Access Compliance Report

Public Rights-of-Way

Intersection ID: 15293	Main Street: ARDSLEY_RD	Cross Street: QUEENS_RD	Location: SW
ADA ID: CC902ED13EC7	Ramp Type: MedianPerp	Initial Pass/Fail: Fail	Overall Compliance: No
			Severity Score: 18.75

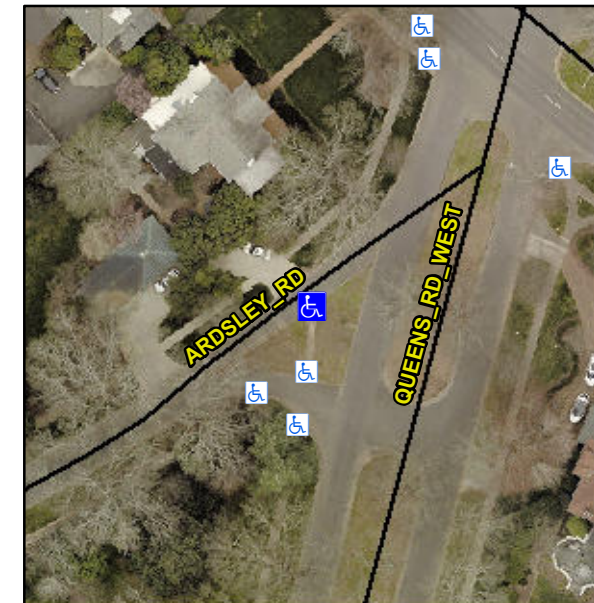
Not Found, R304.5.1, R304.5.3

Compliance	Description	Data	Compliance	Description	Data
N/A	Ramp Length (in)	92.0	Yes	Ramp Slope (%)	5.5
No	Ramp Width (in)	35.0	No	Ramp XSlope (%)	4.8
N/A	Flare Type LT	N/A	N/A	Flare Type RT	N/A
N/A	Flare Slope LT (%)	N/A	N/A	Flare Slope RT (%)	N/A
N/A	Flare Traversable LT?	N/A	N/A	Flare Traversable RT?	N/A
N/A	Landing Length (in)	N/A	N/A	DWS Provided?	N/A
N/A	Landing Width (in)	N/A	N/A	DWS Contrast?	N/A
N/A	Landing Slope (%)	N/A	N/A	DWS Length (in)	N/A
N/A	Landing X Slope (%)	N/A	N/A	DWS Full Width?	N/A
N/A	Landing Curb? (Y/N)	N/A	N/A	DWS Offset (in)	N/A
N/A	Shared Landing?	N/A			
N/A	Gutter Ponding?	N/A	N/A	Gutter Slope (%)	N/A
N/A	Gutter Lip Ht (in)	N/A	N/A	Gutter X Slope (%)	N/A
N/A	Painted X Walk1?	No	N/A	Painted X Walk2?	N/A
	X Walk 1 Direction	To N		X Walk 2 Direction	N/A
N/A	X Walk 1 Width (in)	N/A	N/A	X Walk 2 Width (in)	N/A
	X Walk 1 Slope (%)	4.2		X Walk 2 Slope (%)	N/A
	X Walk 1 X Slope (%)	0.2		X Walk 2 X Slope (%)	N/A

Remove & Replace Entire Ramp.
